Access Compliance Report

Public Rights-of-Way (Curb Ramps)

Intersection ID: 17204	Main Street: PROVIDENCE_RD	Cross Street: VERNON_DR	Location: SE
ADA ID: 0FE07A9FAB36	Ramp Type: PerpDiag	Initial Pass/Fail: Fail	Overall Compliance: No
		Severity Score: 25

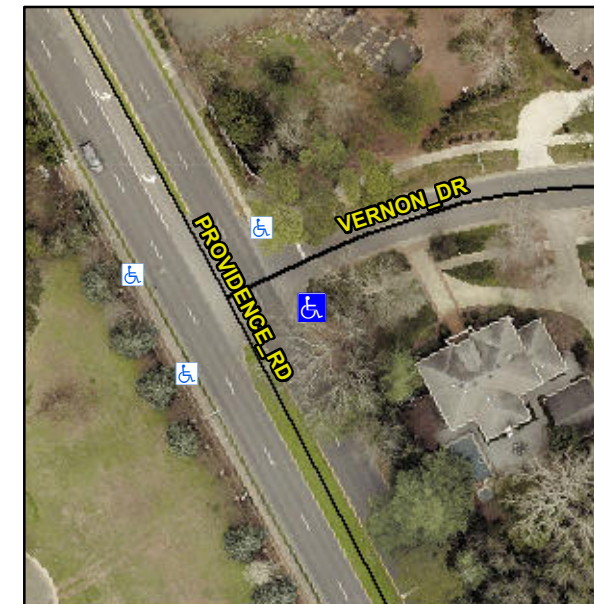
Not Found, R304.2.2, R304.5.3

Compliance	Description	Data	Compliance	Description	Data
N/A	Ramp Length (in)	48.0	No	Ramp Slope (%)	10.8
Yes	Ramp Width (in)	48.0	No	Ramp XSlope (%)	6.0
N/A	Flare Type LT	N/A	N/A	Flare Type RT	N/A
N/A	Flare Slope LT (%)	N/A	N/A	Flare Slope RT (%)	N/A
N/A	Flare Traversable LT?	N/A	N/A	Flare Traversable RT?	N/A
N/A	Landing Length (in)	N/A	N/A	DWS Provided?	N/A
N/A	Landing Width (in)	N/A	N/A	DWS Contrast?	N/A
N/A	Landing Slope (%)	N/A	N/A	DWS Length (in)	N/A
N/A	Landing X Slope (%)	N/A	N/A	DWS Full Width?	N/A
N/A	Landing Curb? (Y/N)	N/A	N/A	DWS Offset (in)	N/A
N/A	Shared Landing?	N/A			
N/A	Gutter Ponding?	N/A	N/A	Gutter Slope (%)	N/A
N/A	Gutter Lip Ht (in)	N/A	N/A	Gutter X Slope (%)	N/A
N/A	Painted X Walk1?	No	N/A	Painted X Walk2?	No
	X Walk 1 Direction	To NW		X Walk 2 Direction	To SW
N/A	X Walk 1 Width (in)	N/A	N/A	X Walk 2 Width (in)	N/A
	X Walk 1 Slope (%)	4.2		X Walk 2 Slope (%)	3.2
	X Walk 1 X Slope (%)	3.1		X Walk 2 X Slope (%)	1.5

Remove & Replace Curb Ramp With Two New Directional Ramps or Equivalent.
